From: "Anne Zareh" <Anne.Zareh@braziermotti.com.au>
Sent: Thu, 25 Sep 2025 11:07:30 +1000
To: "Development Assessment" <developmentassessment@townsville.qld.gov.au>
Cc: "Taryn Pace" <taryn.pace@townsville.qld.gov.au>
Subject: MCU25/0054 - Information Request Response -2 Treeline Drive, Rasmussen
Attachments: 43126-020-03 Response to RFI compiled.pdf

**RESPONSE TO INFORMATION REQUEST
DEVELOPMENT APPLICATION FOR MATERIAL CHANGE OF USE (MCU25/0054)
2 TREELINE DRIVE, RASMUSSEN**

Brazier Motti act on behalf of the applicant, Urbex Pty Ltd, with respect to the abovementioned development proposal, and refer to the Information Request (IR) issued by Townsville City Council ('the Council') on the 18th September 2025. The information and supporting documentation herein represent the applicant's full response to the IR.

2 BINS ENCLOSURE - PLAN
1 : 50

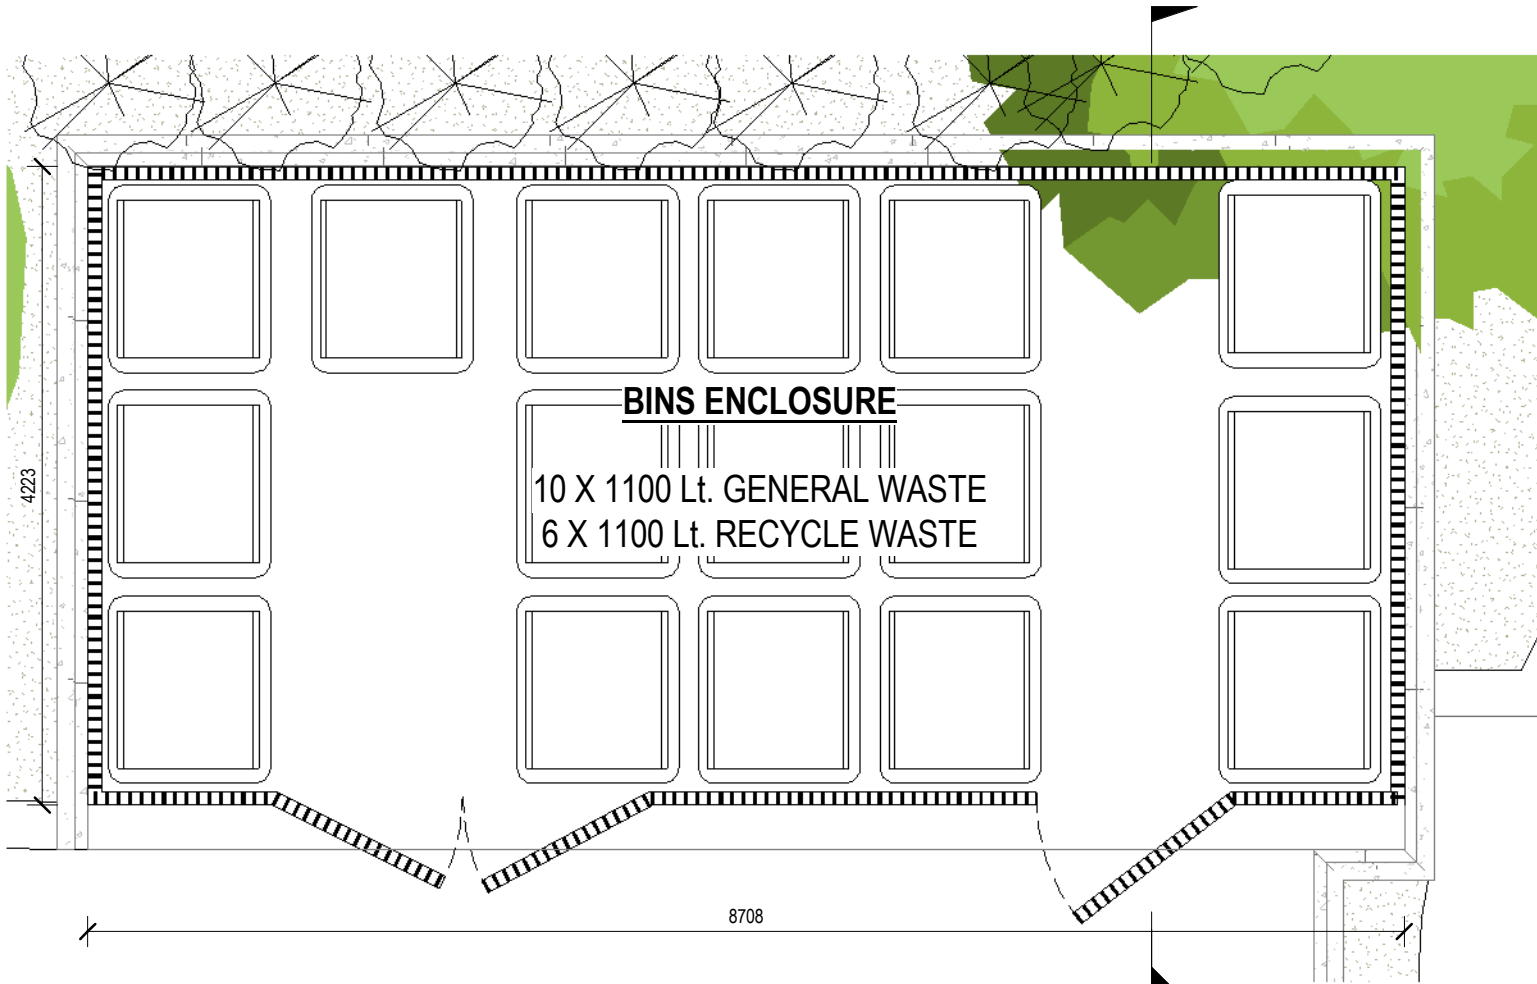
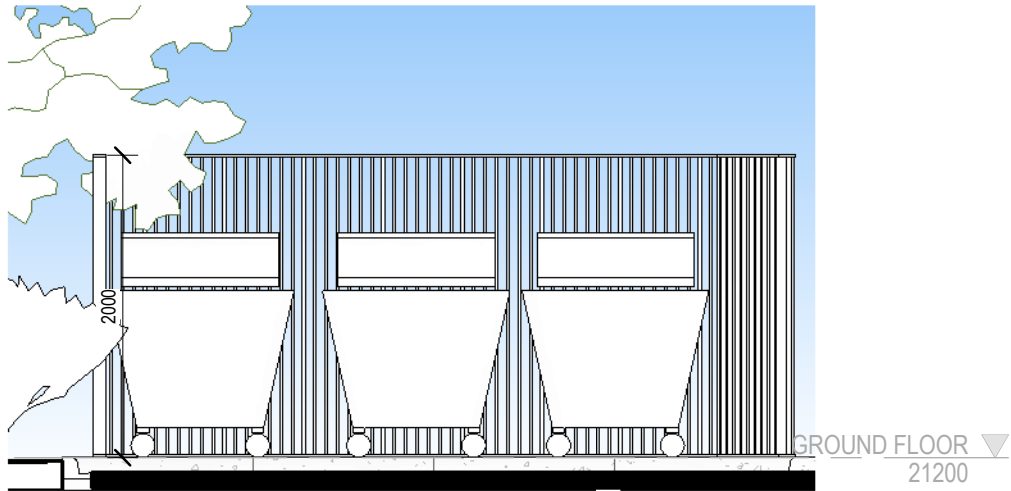
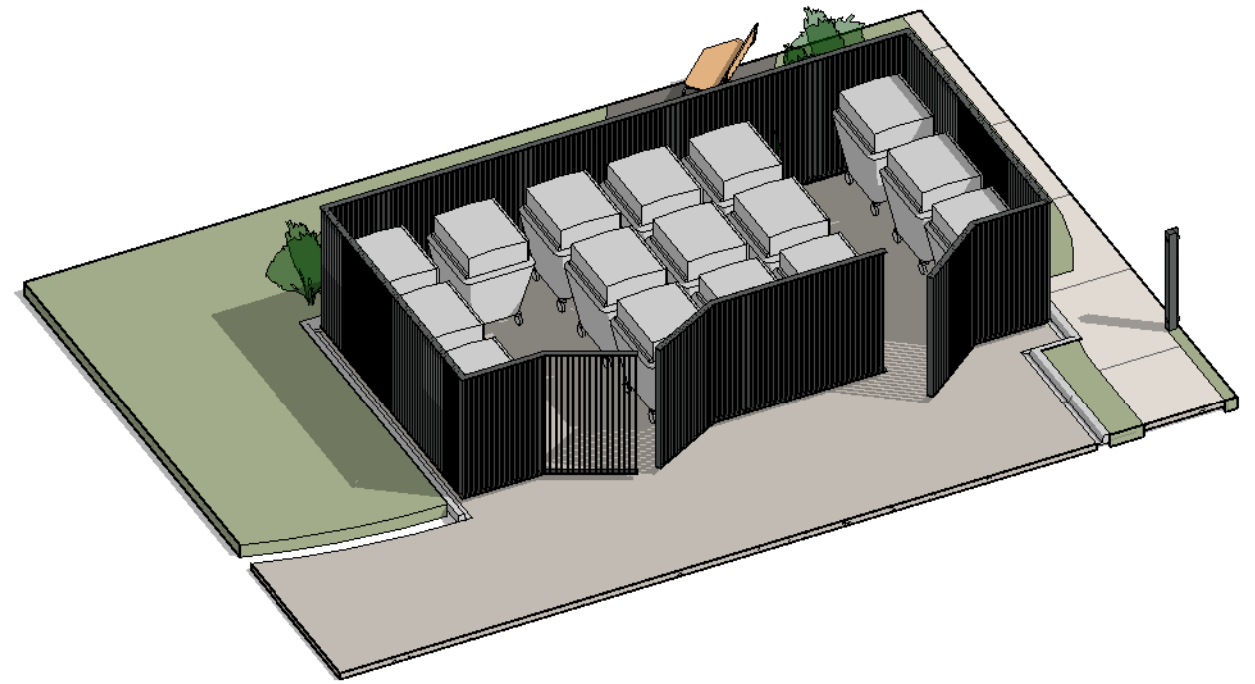
The applicant is requested to provide a Waste Management Plan prepared in accordance with Development Manual Planning Scheme Policy SC6.4.22 - Waste management.

The concept plan has been updated to include an amended bin storage area including a bin storage capacity of 10 x 1100l general waste and 6 x 1100l recycle bins. It has been confirmed by the operator that the storage capacity is compliant with the proposed residential density.

1 PAVILION - PLAN
1 : 50

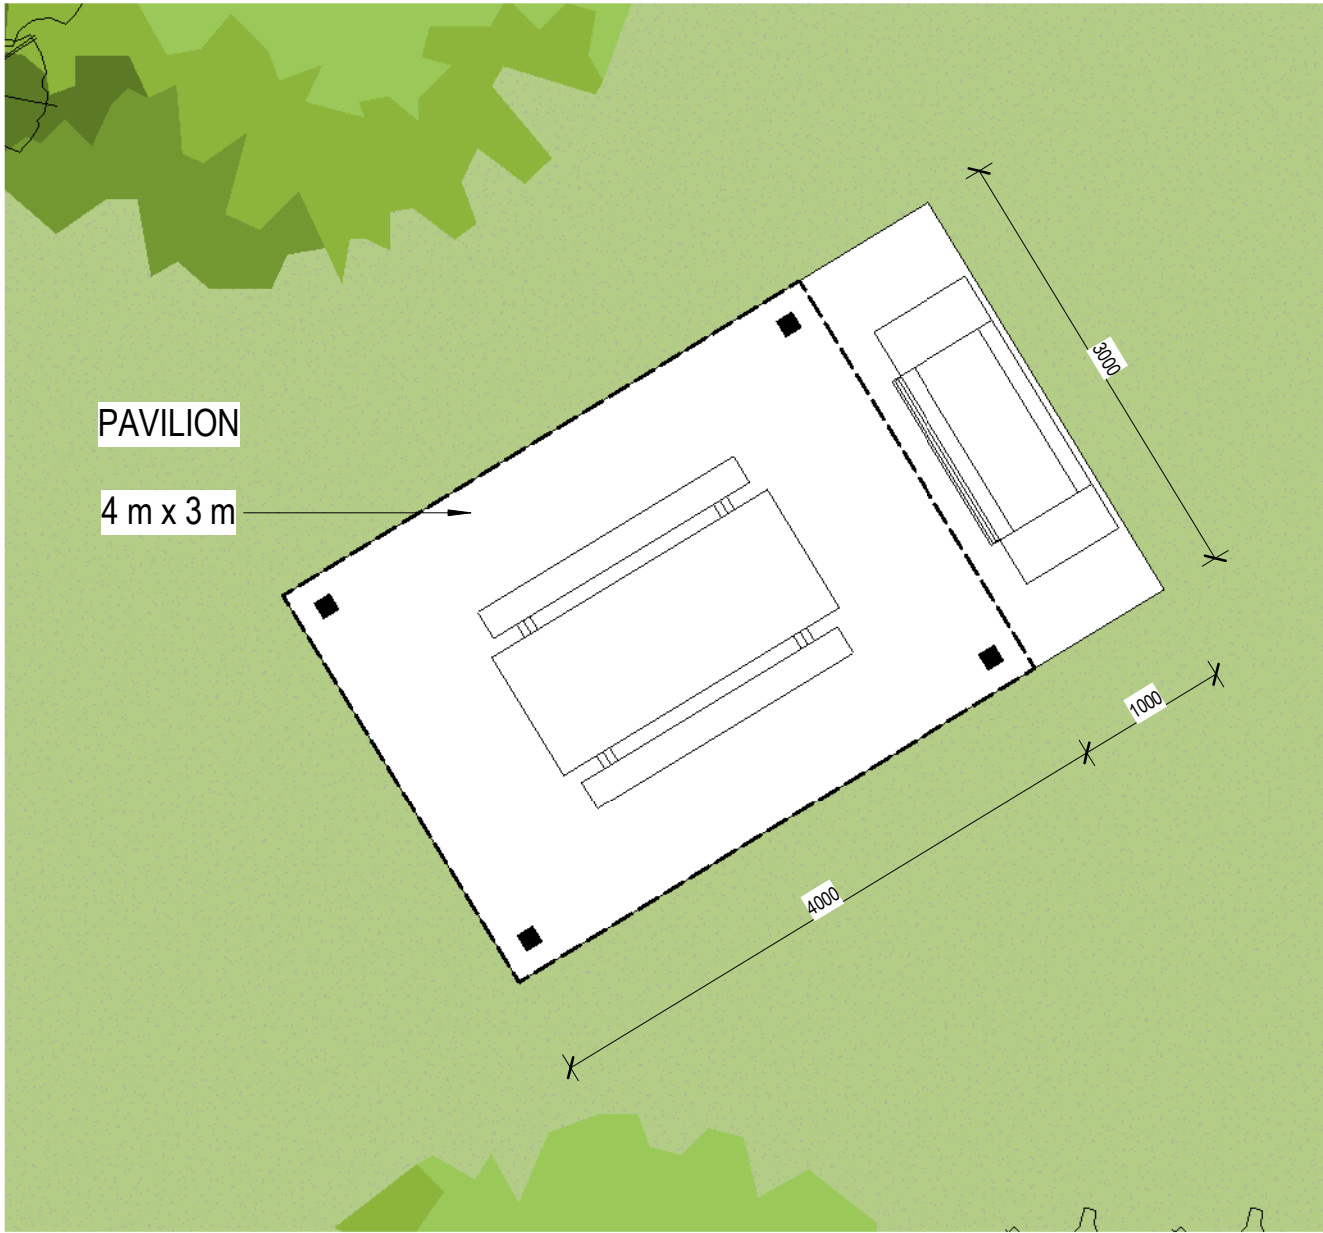
The applicant is requested to provide amended plans demonstrating provision of additional communal open space to service the proposed development, inclusive of appropriate facilities/embellishments to create flexible, usable spaces for residents.

The amended concept plans (Appendix A) show the inclusion on a covered seating and BBQ area. Further, the comments in the planning report with respect to connectivity to external open space areas are still relevant and should be considered as part of the assessment.

HOUSE TYPE 1 - 1

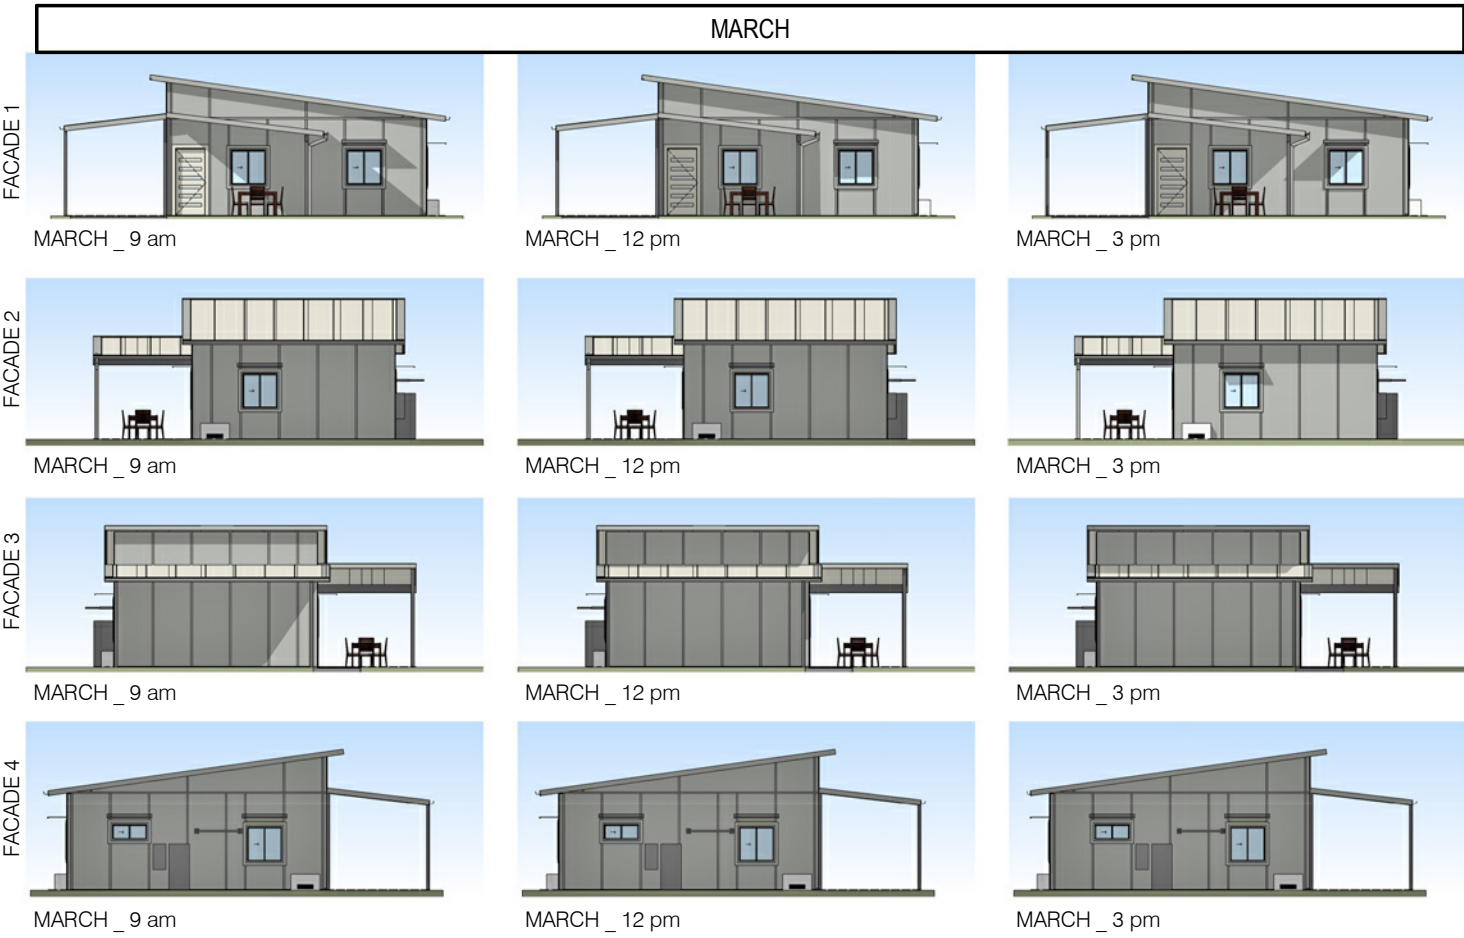
- *Detail of any screening or screen landscaping to assist in privacy and improve usability of private open space proposed in the front of dwelling units;*
- *Solar access diagram/s demonstrating the proposed roof pitches and heights respond to the sun path to maximise shade and weather protection to windows, doors and covered open space. Additional smaller verandah roofs and/ or screening to these areas should also be considered;*
- *The location of any security gate/s to the driveway, if proposed. The location of any gate/s must ensure sufficient space is available onsite for vehicle queuing.*

- Solar diagrams have now been included in the amended concept plan package (**Appendix A**).
- Security gates are not proposed as part of this development.
